SAILOR

Service Information No. 97
Kundendienst-Mitteilung No.
Service Information No.
Información de servicio No.
Servicemeddelelse No.

Date / Datum / Date / Fecha / Dato August, 1985

T2031 FREQUENCY JUMP OF THE SYNTHESSES

Fig. 1

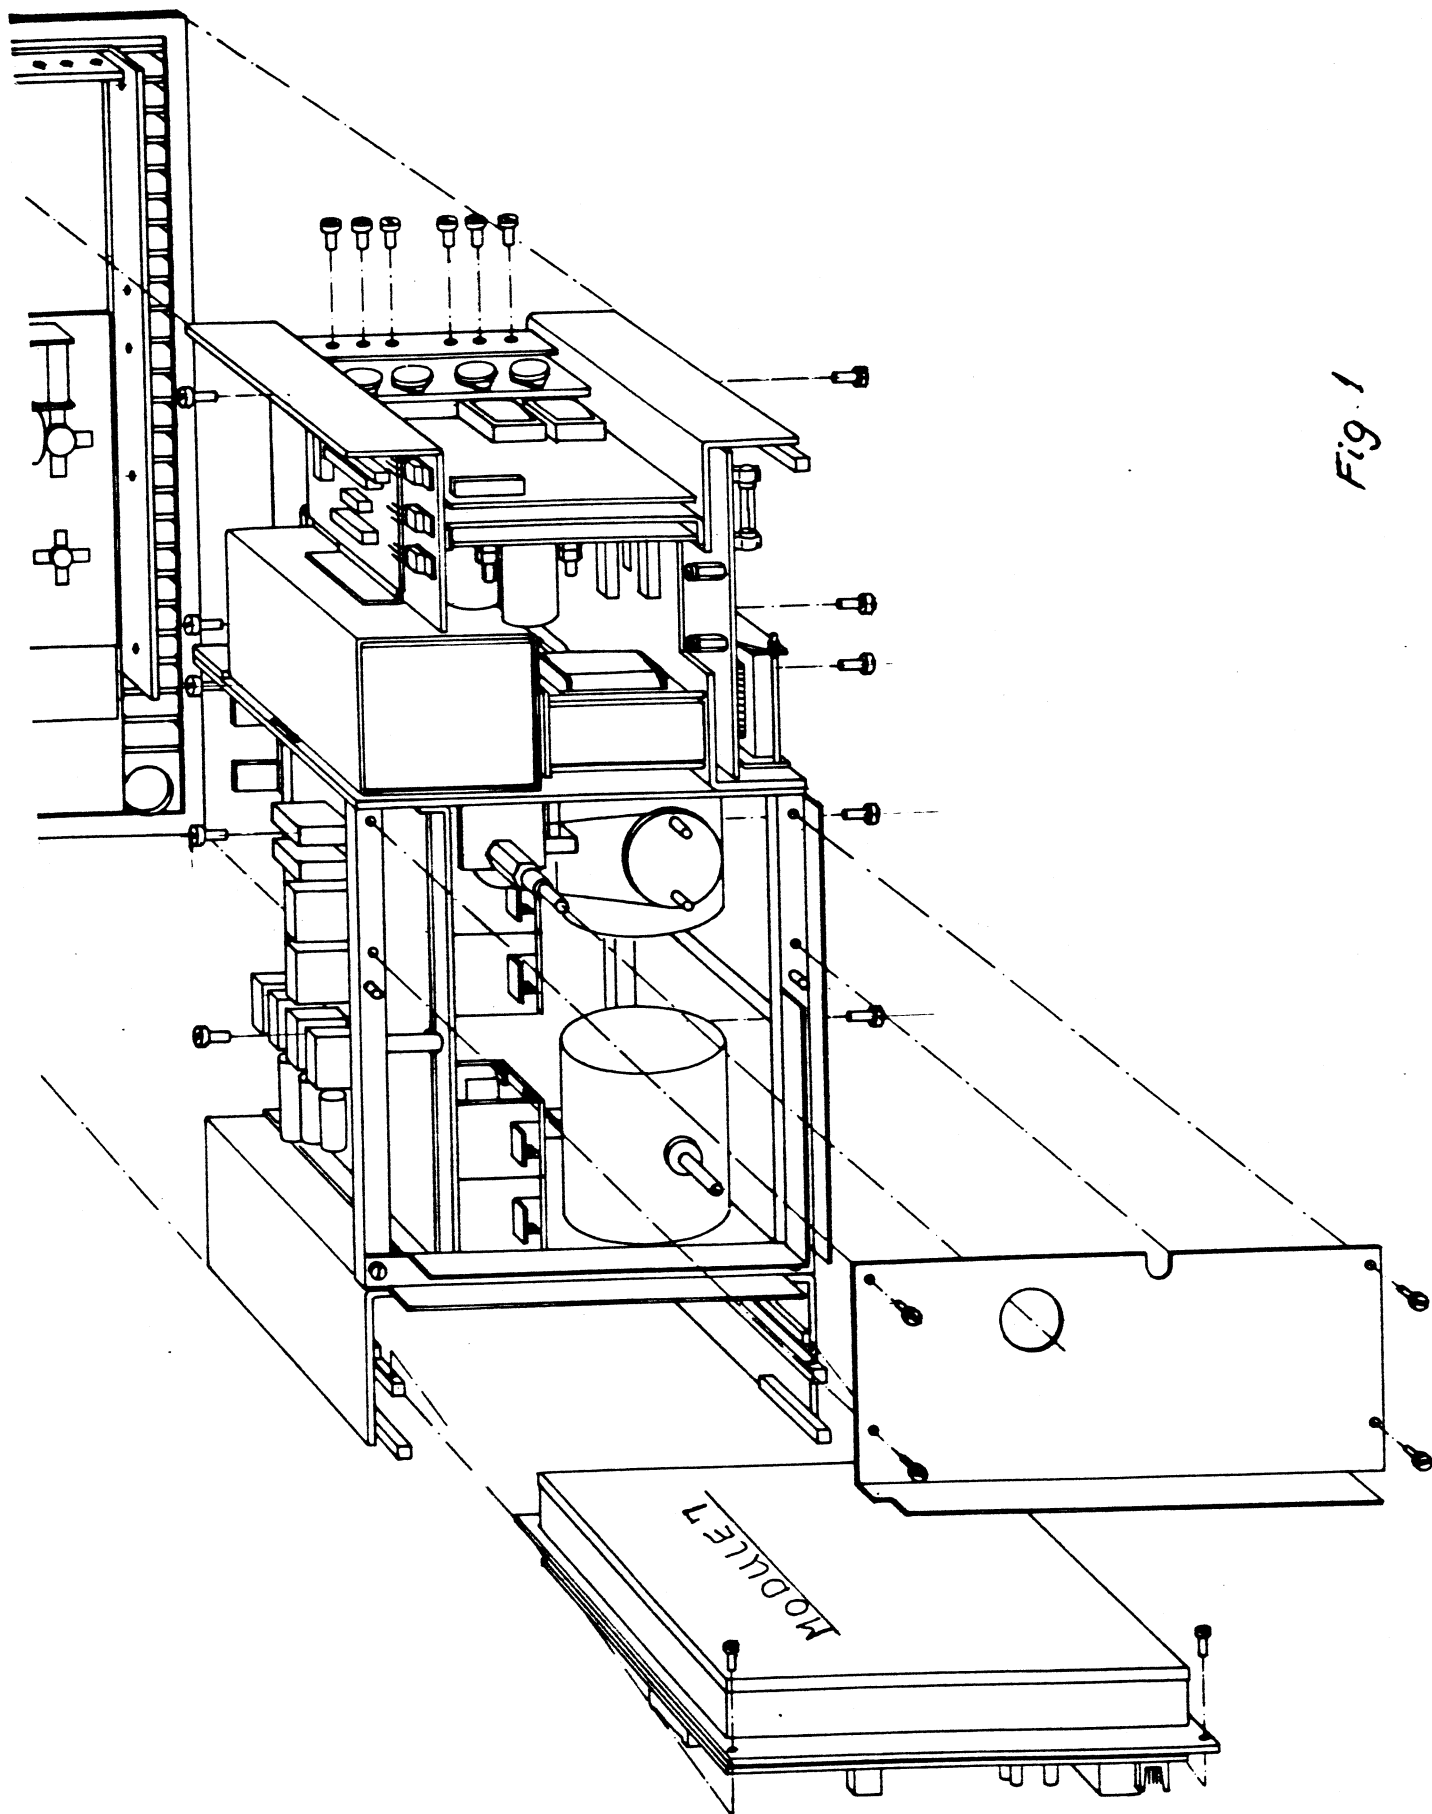
We have experienced that in some T2031 with serial No. lower than 288017 some synthesis have a decoupling capacitor which is mounted wrongly.

If you get trouble with a T2031 due to frequency jump, please perform the following modification.

1. Take out the synthesizer module 7 (see fig. 1).
2. Unsolder the capacitor 4n7 marked xx on fig. 2.
3. Solder it in between 0-0 on fig. 2.
4. Remount the module. No adjustment is necessary.

1. Udtag frequency synthesizer modul 7 (see fig. 1).
2. Udlod kondensatoren 4n7 mærket xx i fig. 2.
3. Ild herefter 4n7 kondensatoren imellem 0-0 på fig. 2.
4. Isæt modulet. Ingen justeringer er nødvendige.
